7.6 All Other Instrumentation Systems Required for Safety

The information in this section of the reference ABWR DCD, including all subsections, tables, and figures, is incorporated by reference with the following departures and supplements.

Table 7.6-4a Basic Configuration of a Typical Neutron Monitoring System Division

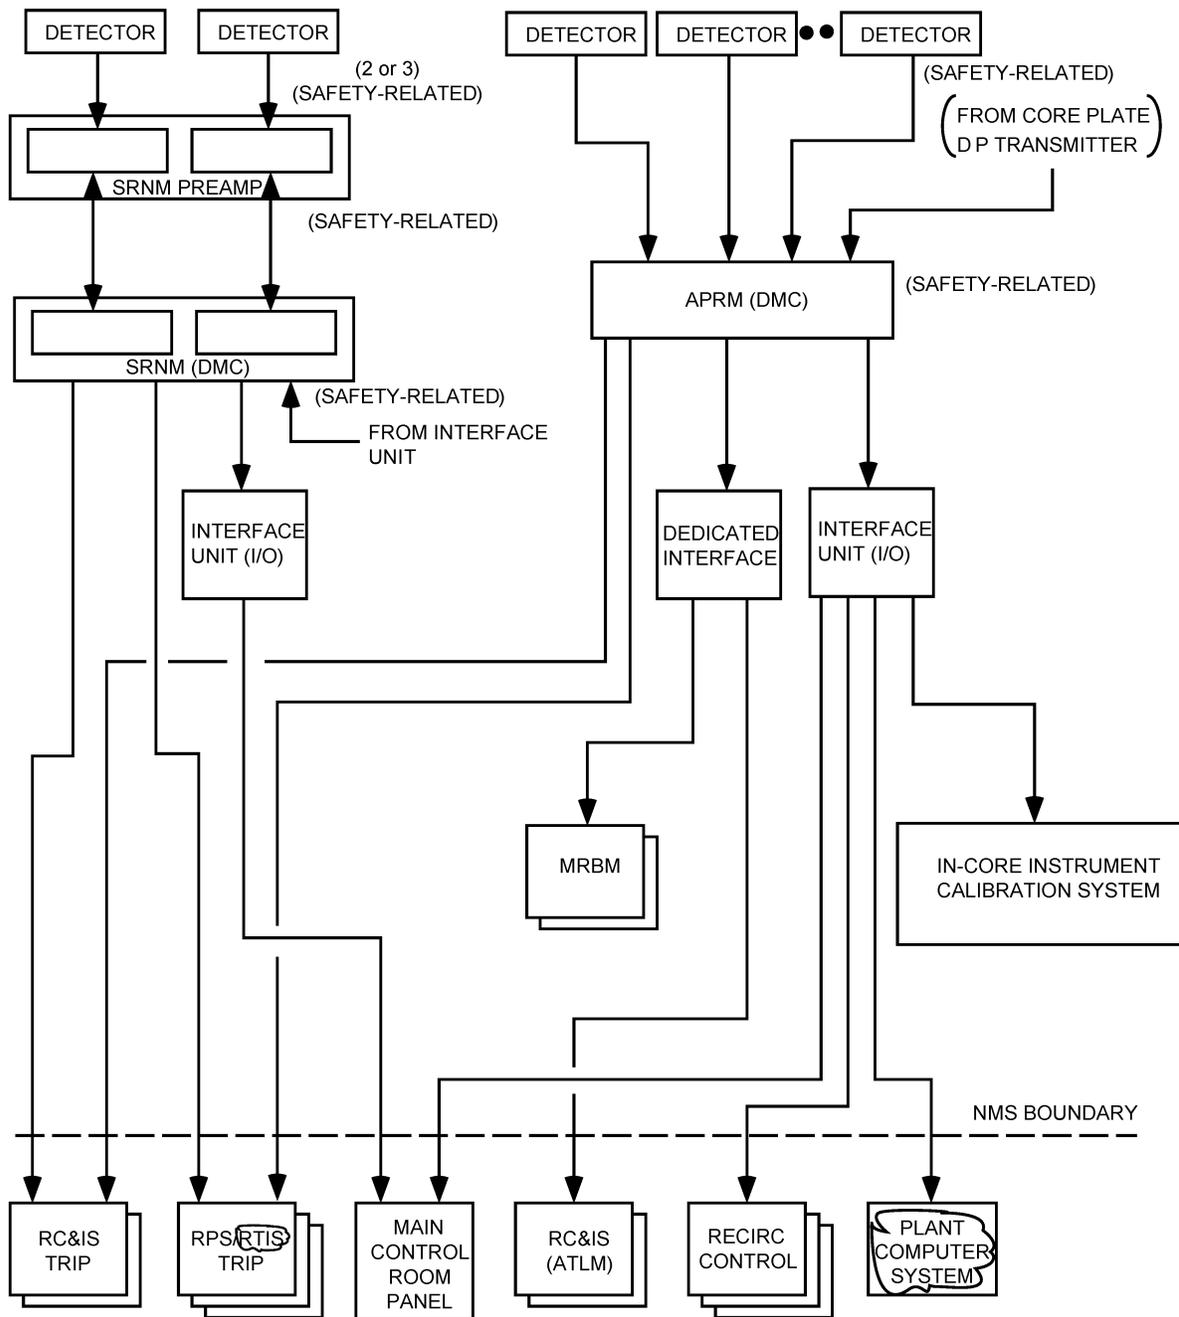
STD DEP T1 3.4-1 (Table 7.6-5 and Figures 7.6-1, 7.6-2, 7.6-4a)

The purpose of the Neutron Monitoring System (NMS) is to monitor power generation and, for the safety function part of the NMS, to provide trip signals to the Reactor Protection System (RPS) to initiate reactor scram under excessive neutron flux (and power) increase condition (high level) or neutron flux fast rising (short period) condition. The NMS also provides power information of operation and control of the reactor to the Plant Process Computer System (PCS) Functions (PCF) and the rod block monitor. A block diagram showing a typical NMS division is shown in Figure 7.6-4a. The operating ranges of the various detectors are shown in Figure 7.6-4b.

Figure 7.6-9 Instrumentation Location Definition for the Suppression Pool Temperature Monitoring System

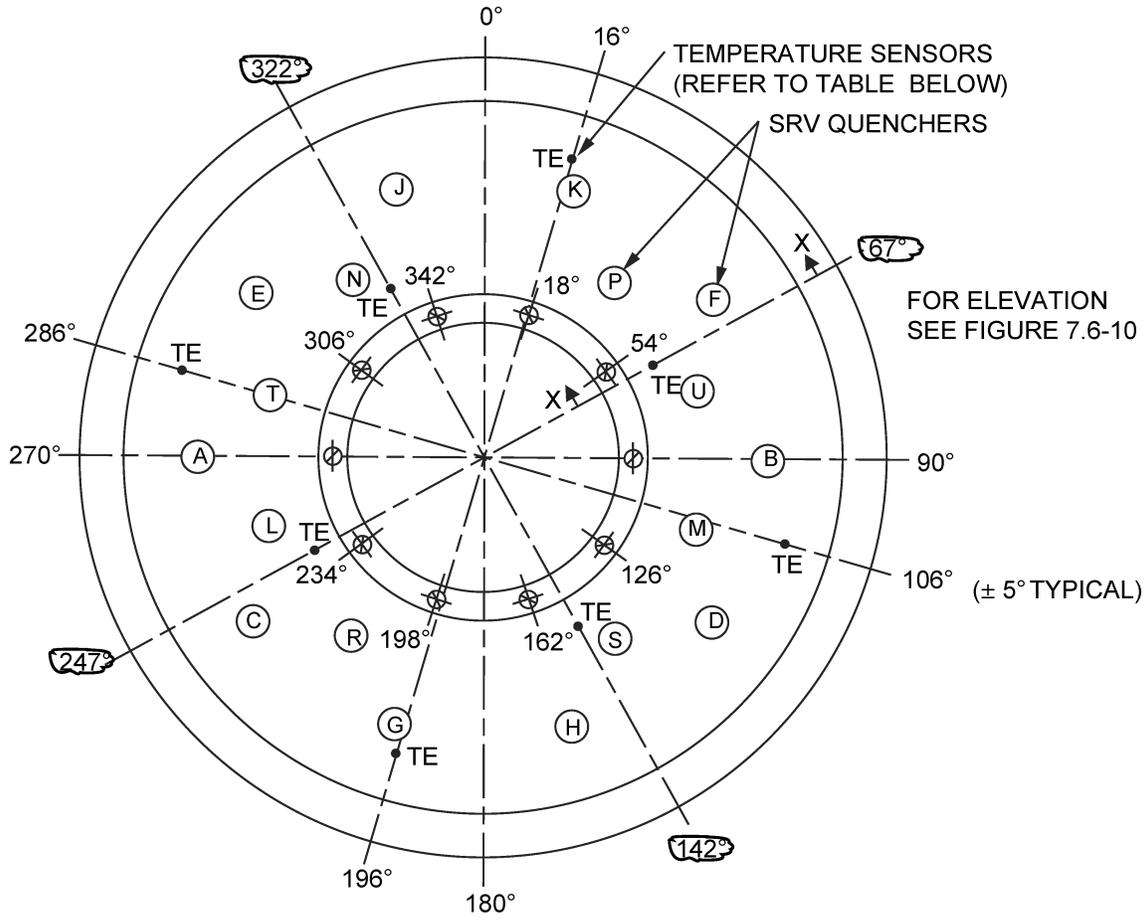
STD DEP 7.6-3 (Figures 7.6-9, 7.6-11, 7.6-12)

The SPTM System configuration is shown in Figures 7.6-9 and 7.6-10. There are eight temperature circumferential sensor locations (Figure 7.6-9), which are chosen based upon the following considerations:

- (2) Each SRV discharge line quencher is in direct sight of two sets of temperature sensors within 9 meters.

Figure 7.6-14 OPRM Logic

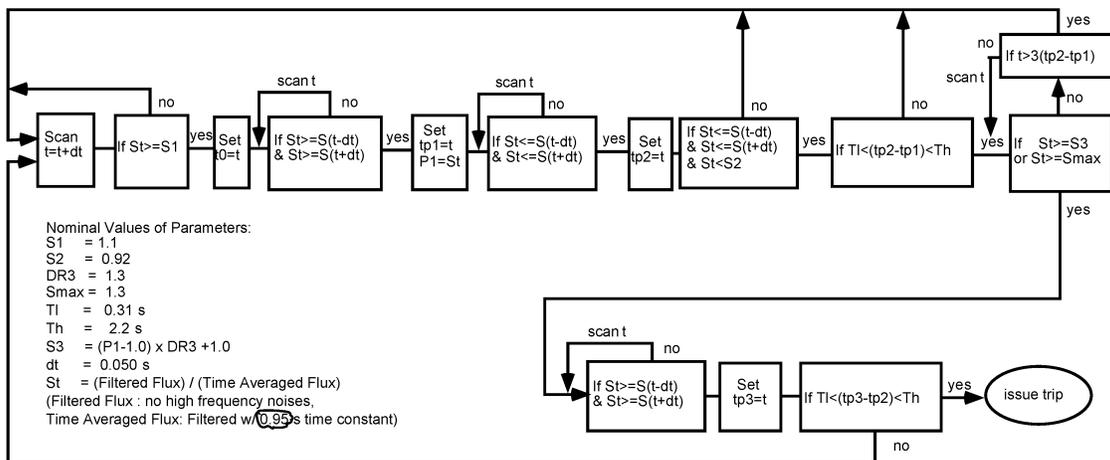
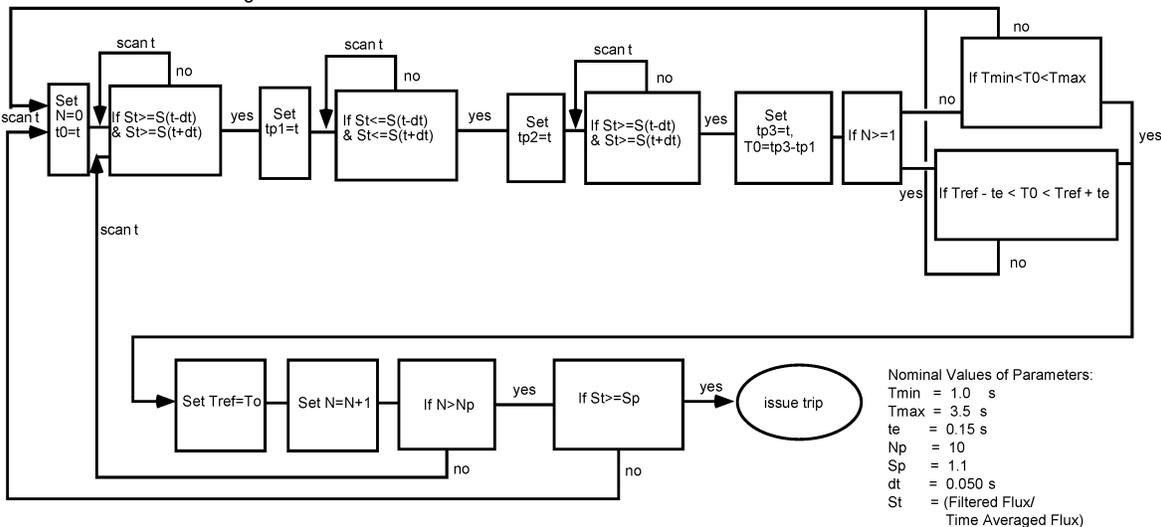
STD DEP 7.6-1 (Table 7.6-2 and Figures 7.6-2, 7.6-14)

For the OPRM trip function, the response signal of any one OPRM cell that satisfies the conditions and criteria of the trip algorithm will cause a trip of the associated OPRM channel. Figure 7.6-14 illustrates the trip algorithm logic. ~~The OPRM trip function does not have its own inoperative trip for insufficient number of total LPRM inputs in the channel. It follows the APRM's inoperative trip of insufficient number of LPRMs.~~ The OPRM function has its own inoperative trip when the channel has less than the required minimum operable cells, or there is an OPRM self-test fault, or the APRM instrument firmware/software timer has timed out, if there is a loss of power to the APRM instrument.

$T_{min}=1$ s, $T_{max}=3.5$ s, $\pm t_{error}=\mathbf{0.15}$ s $\mathbf{0.1}$ s, $N_P=10$.
(For details see Figure 7.6-14).
